**CCL 23/03/21 - SCHOLEY STREET AT NELSON STREET,  
MAYFIELD - PROPOSED PEDESTRIAN / CYCLE REFUGE,  
ROAD CUSHIONS AND INTERSECTION REALIGNMENT**

**ITEM-25      Attachment A:      Scholey Street at Nelson Street, Mayfield - Plan**

**ITEM-25    Attachment B:    Scholey Street, Mayfield - Summary of  
Submissions**

**SUMMARY OF SUBMISSIONS  
SCHOLEY STREET, MAYFIELD – PROPOSED PEDESTRIAN REFUGE AT NELSON STREET**

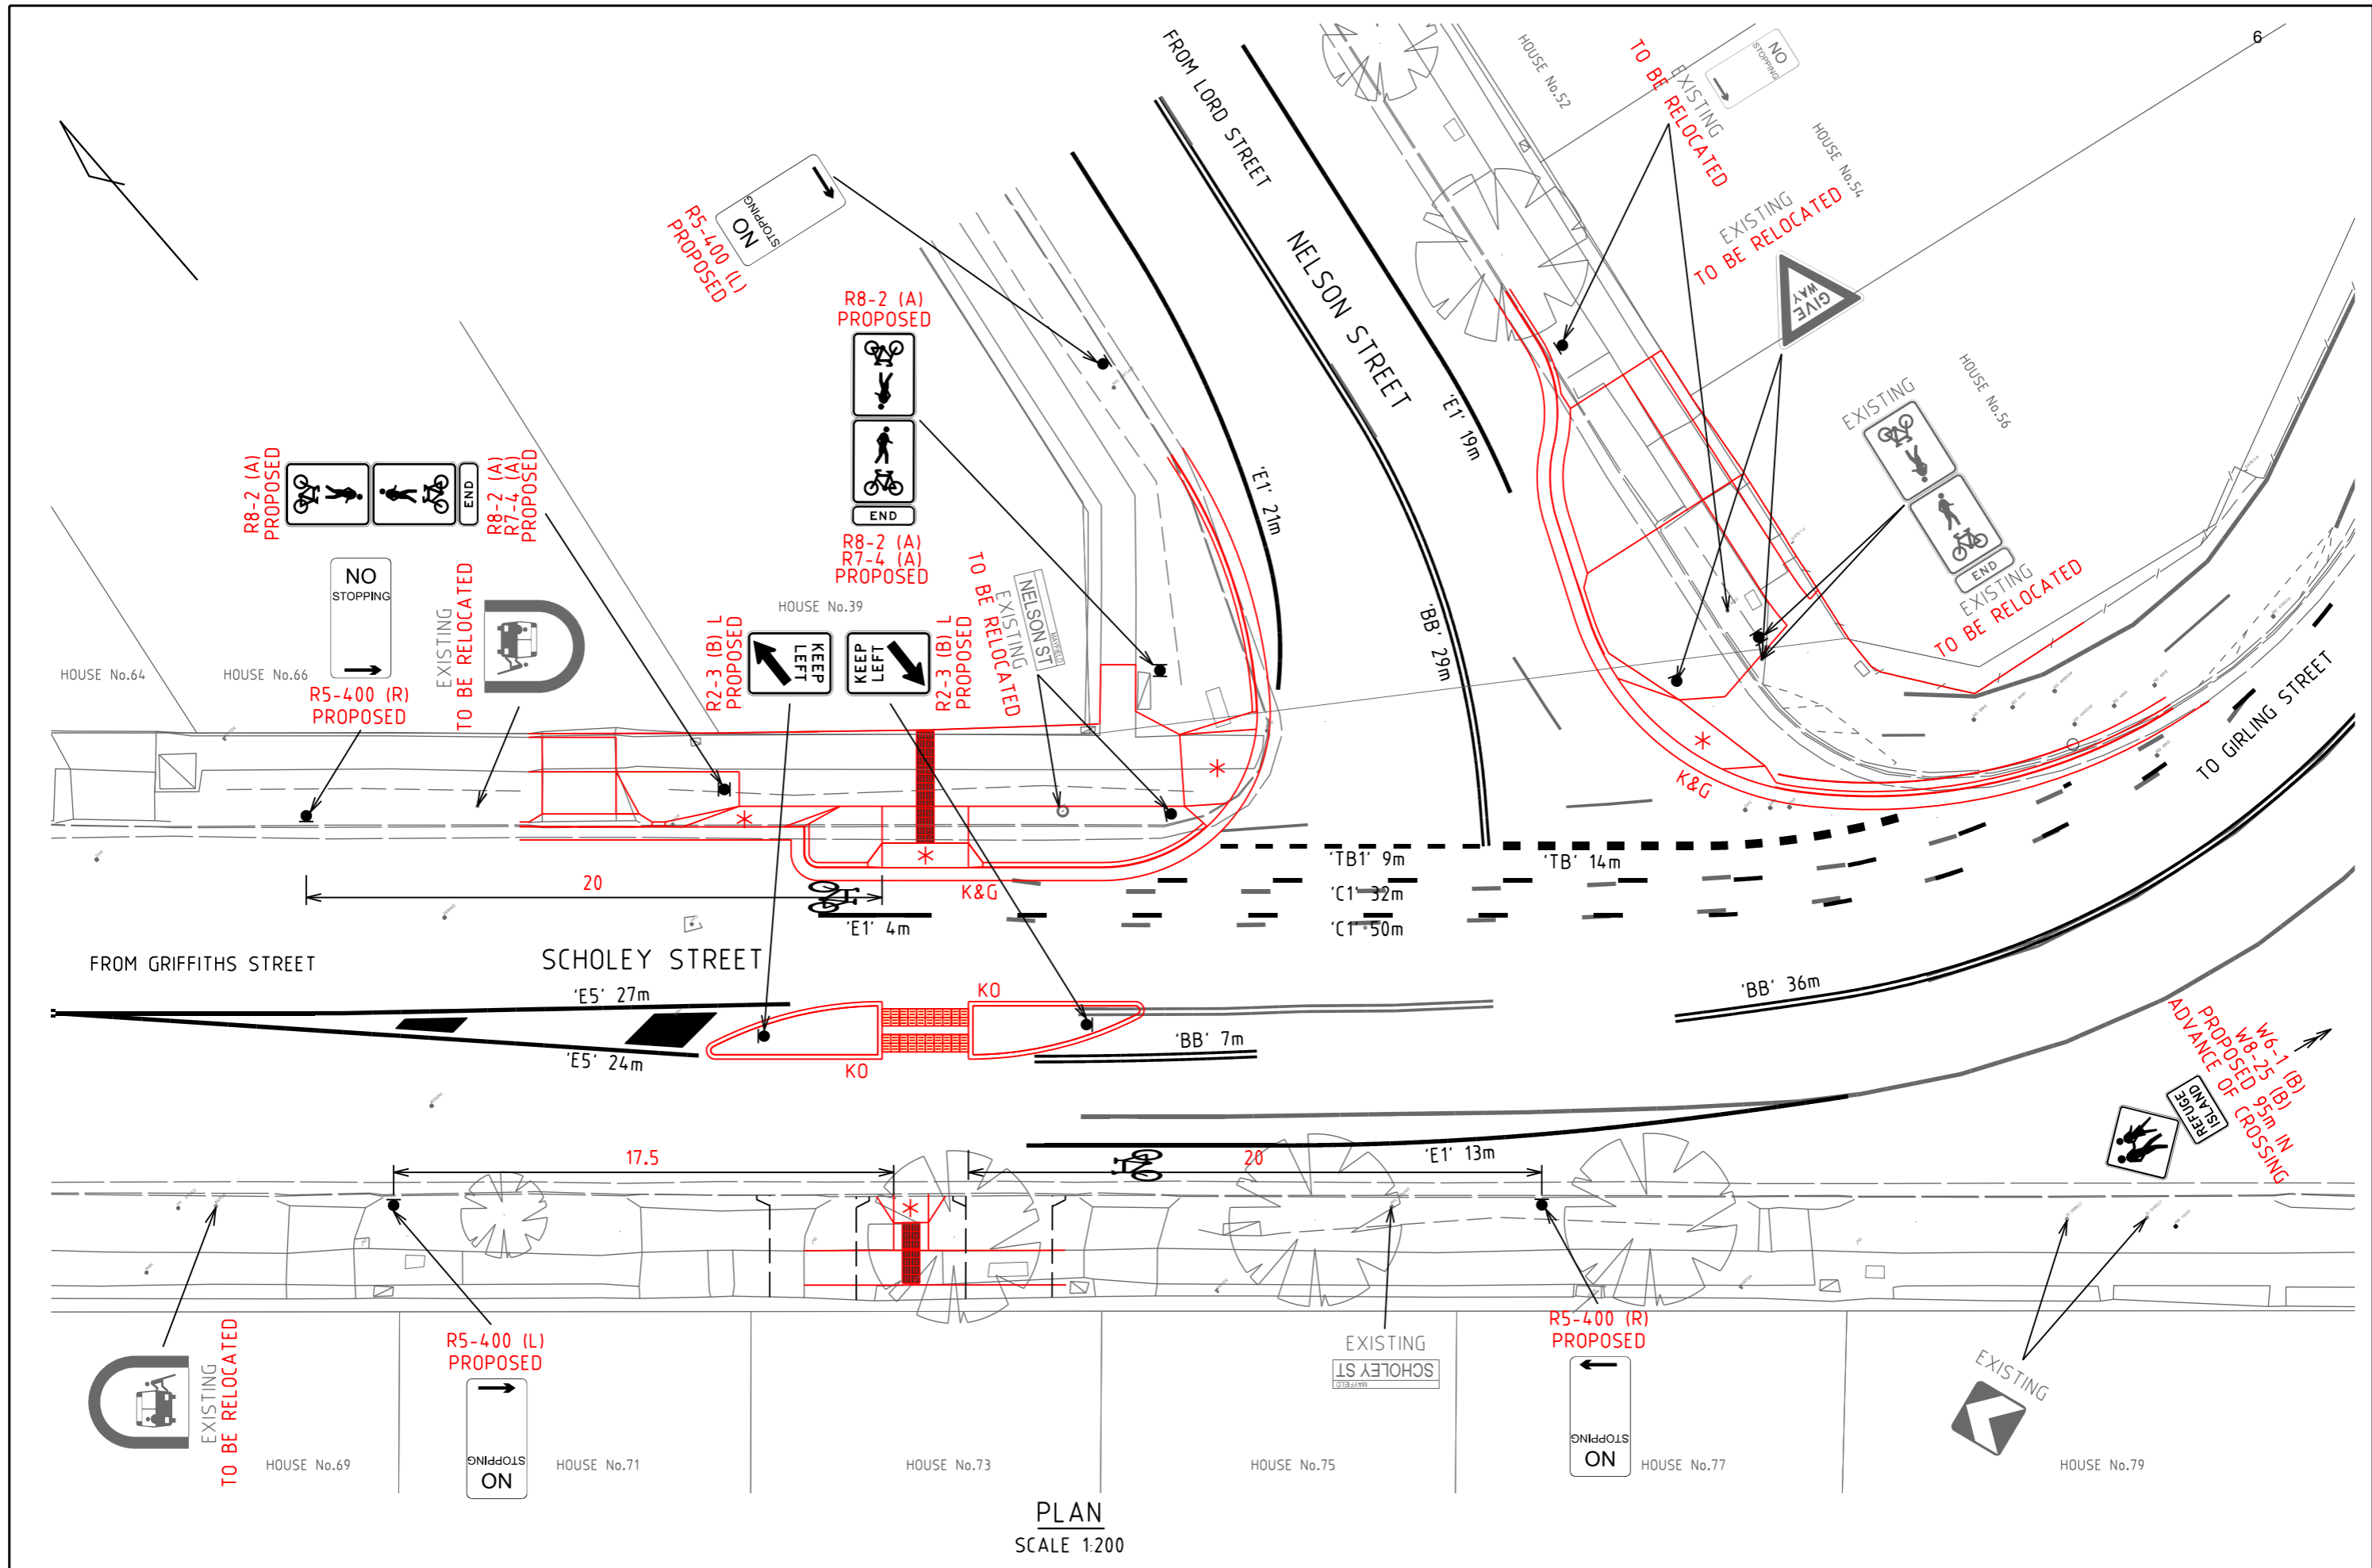
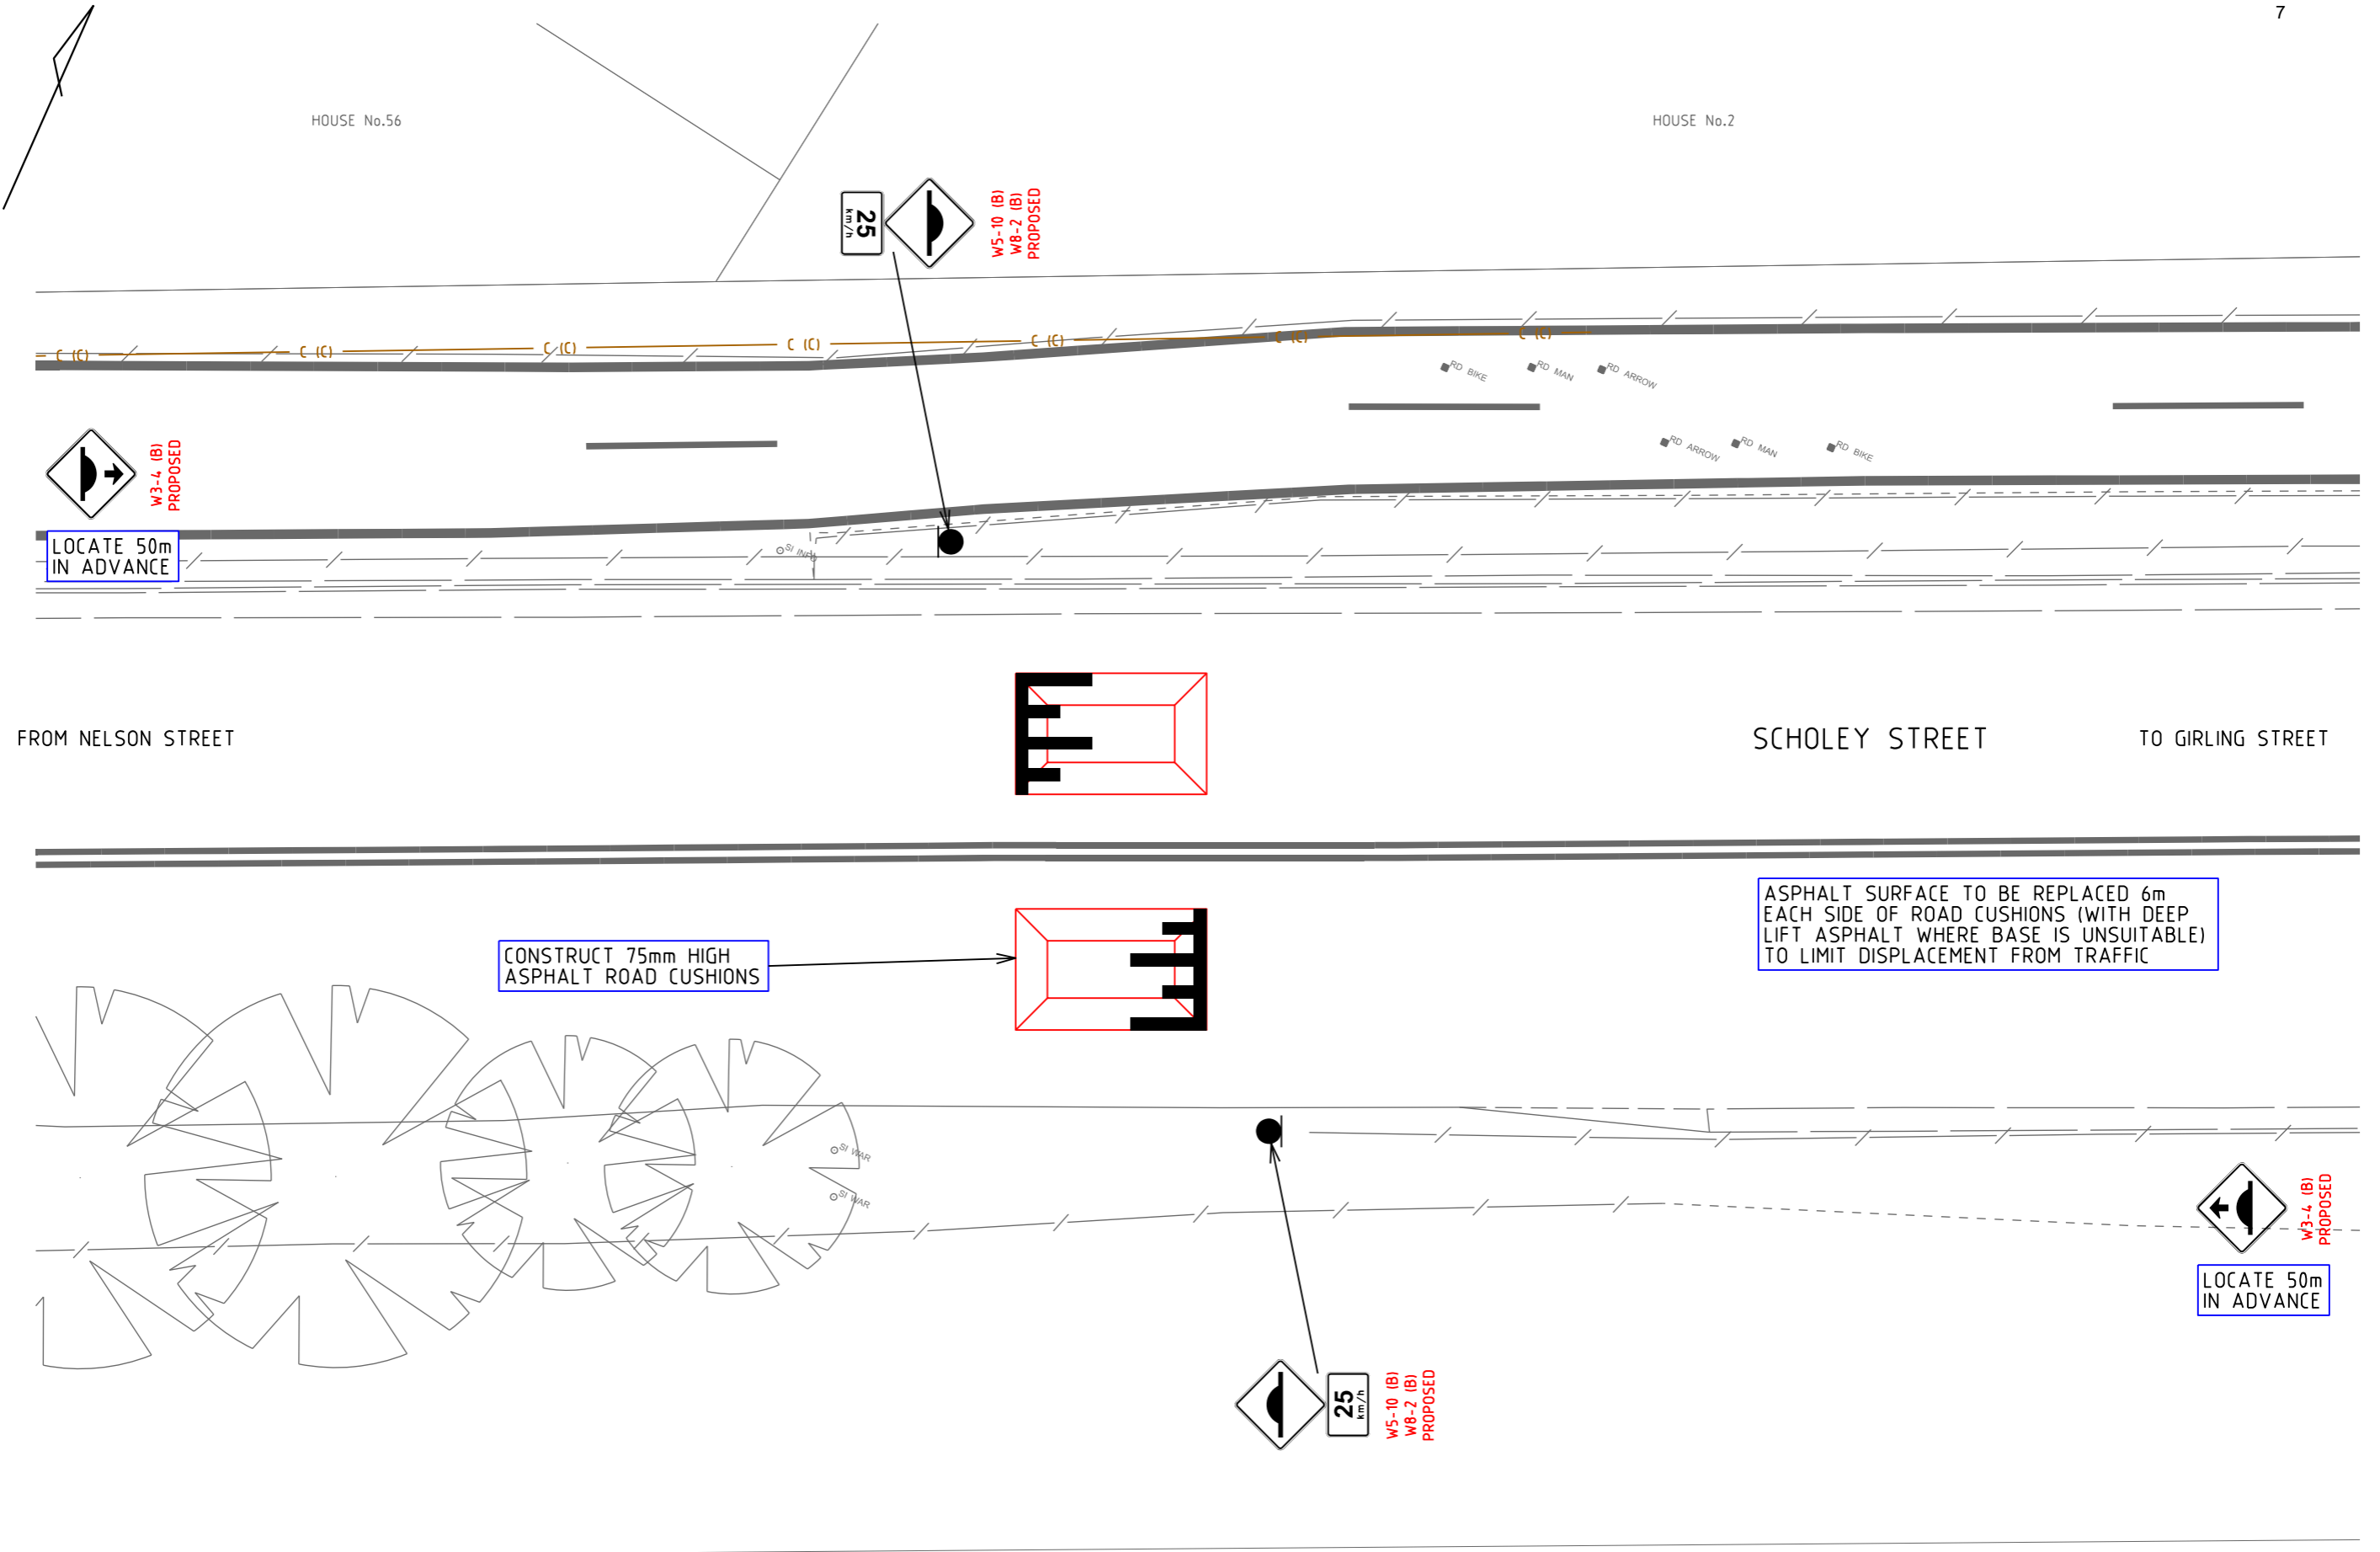
No.	P&R	Street/Suburb	Support Measures?	Summary of Submission	CN Comment
1	TR2020/01133	Scholey St	No	Respondent states that speeding in the area is the main problem, with the proposed refuge likely to increase the danger faced by all road users. They assert that the camber of the road with the proposed refuge (specifically the western splayed approach) will render access to their driveway from the westbound lane impossible. The respondent notes that they judge the crossing of Nelson Street to be the greater danger to pedestrians, as opposed to the crossing of Scholey Street.	The presence of the refuge in the roadway should act to calm traffic in Scholey Street. Access to the driveway will be possible. Road cushions have been included in the project scope for further traffic calming. Kerb extensions at Nelson Street will improve sight lines.
2	TR2020/01183	Nelson St	Yes, with changes	The respondent states that they agree with the refuge on Scholey Street, but assert that the crossing on Nelson Street presents a greater risk to pedestrians as pedestrians are essentially blind to traffic approaching from either direction on Scholey Street in addition to westbound traffic often speeding up/crossing the centreline around corners at this location. They note that audible indicators of vehicular traffic are often drowned-out by activity in the nearby rail corridor, further increasing the hazard posed to pedestrians. The applicant requests that an additional pedestrian refuge be considered on Nelson Street.	Noted. An additional refuge on Nelson Street was investigated. Incorporation of the refuge meant that the planned kerb extensions would not be possible, crossing would be in two stages and crossing distance not markedly reduced. It was considered that the exhibited arrangement would be more effective in addressing the reported issues.

3	TR2020/01296	Scholey St	No	The respondent advises that they have development consent for a new driveway at No. 73 which is directly impacted by the southern kerb ramp of the proposed crossing with pedestrian refuge, noting that the proposed refuge will make access 'very difficult and quite dangerous'. They request the refuge be relocated west by approximately 'two properties'.	<p>CN design staff have reported that the two driveways approved will not impede the installation of the pedestrian facilities, specifically the kerb ramp and Tactile Ground Surface Indicators. They note additionally that the space between the driveways as shown on the design supplied by this respondent is 2.71m. The pedestrian facilities which may have overlapped will be approximately 2.4 m wide.</p> <p>The refuge is to be located to allow transition from the off-road path on the Scholey Street bridge to on road, for continuation of travel west.</p>

4	(NA – online submission)	Mayfield	Yes, with changes	Respondent suggested moving the refuge further west towards Purdue Park, to allow	The refuge is to be located to allow transition from the off-road path on the Scholey Street

No.	P&R	Street/Suburb	Support Measures?	Summary of Submission	CN Comment
				retention of parking between No. 71 and No. 77 Scholey Street. Respondent queried why Scholey Street could not have a treatment similar to Roe, Valencia and Hart streets.	bridge to on road, for continuation of travel west. Roe, Valencia and Hart streets have a threshold treatment, which is primarily a traffic calming device rather than a crossing facility. Guidelines discourage use of traffic calming devices on pedestrian desire lines. Road cushions are proposed east of Nelson Street.
5	(NA – online submission)	Islington	Yes, with changes	Respondent considers that: Nelson Street requires a refuge; cars speed down the bridge, heading west; refuge islands are too small (cannot accommodate trailers or tag-a-longs) and bike symbols are confusing. Buffers (in accordance with Road Rules) should be provided.	An additional refuge was investigated, however, the exhibited proposal, with the addition of road cushions, is considered the best option. Facilities are designed in accordance with Austroads and Transport for NSW guides and technical directions. It is acknowledged that larger bikes and mobility devices are more common, however site constraints dictate what can be accommodated.

6	(NA – online submission)	Merewether	Yes, with changes	Respondent indicates that the design is not compatible with Road Rule 144. Respondent considers that refuge islands are too small and cannot accommodate trailers or tag-a-longs.	Road 144 indicates that 'the driver of a motor vehicle driving past to the right of a bicycle that is travelling on a road in the same direction as the motor vehicle must pass the bicycle at a safe distance from the bicycle'. The safe distance is at least one metre if the speed limit is less than 60km/h. This is primarily a behavioural issue. The onus is on the driver to pass at a safe distance or wait (behind the rider) until it is possible to do so safely. It is acknowledged that larger bikes and mobility devices are more common, however site constraints dictate what can be accommodated.
7	(NA – online submission)	Mayfield	No	Respondent suggests adding a separated cycleway on the southern side of the bridge or close the bridge to traffic. Respondent considers that the proposal does not address any of the conflict areas.	The bridge has recently been upgraded. The bridge is not a CN asset and significant negotiation and costs were involved to achieve the cycling provisions included in the upgrade.

8	(NA – online submission)	Newcastle East	No	Respondent notes difficulties with bi-directional facilities and considers that it would be cheaper and easier to run protected bike lanes on both sides of the road from Islington Park to Gardiner Street.	Noted.
9	(NA – online submission)	Mayfield	Yes, with changes	Respondent queries the need for the bus stops (noting another bus stop 300m west on Scholey	Removal of the bus stops has not been considered as part of this proposal. Bus stop

No.	P&R	Street/Suburb	Support Measures?	Summary of Submission	CN Comment
				Street) and notes imminent increased need for on street parking, with development at No. 73 Scholey Street. Respondent requests additional traffic calming at the bottom of the rail bridge. Respondent supports provision of a pedestrian refuge.	locations and spacing are determined primarily by Transport for NSW and Newcastle Transport. Road cushions have been incorporated in the project scope.
10	(NA – online submission)	Cooks Hill	Yes, with changes	Respondent notes difficulty with performing a right turn from Nelson Street into Scholey Street, due to sight lines. Would like visibility improved.	Implementation of the refuge and road cushions should assist with moderating speeds. These measures and realignment of the intersection should improve the safety of the right turn.
11	(NA – online submission)	Mayfield	Yes	Respondent requests a mirror on Scholey Street, noting that mirrors are not 'preferred' treatments. They request an additional pedestrian refuge or plastic bollard median treatment on Nelson Street, as well as measures to slow traffic departing the rail bridge on Scholey Street.	Mirrors are not supported road treatments. An additional refuge on Nelson Street was investigated but raised other issues. The exhibited proposal, with the addition of road cushions, is preferred.

12	(NA – online submission)	Hamilton	Yes	No comments provided.	Noted.
13	(NA – online submission)	The Hill	No	Respondent considers the refuge is not required as few pedestrians cross at the intersection. Respondent objects to loss of parking.	Noted.
14	(NA – online submission)	Islington	No	Respondent considers a refuge is needed to cross Nelson Street, noting poor sightlines. Respondent suggests remaining on the north side of Scholey Street until clear then crossing.	Purpose of the refuge is to facilitate the movement described. Realignment of the intersection is intended to improve sight lines.
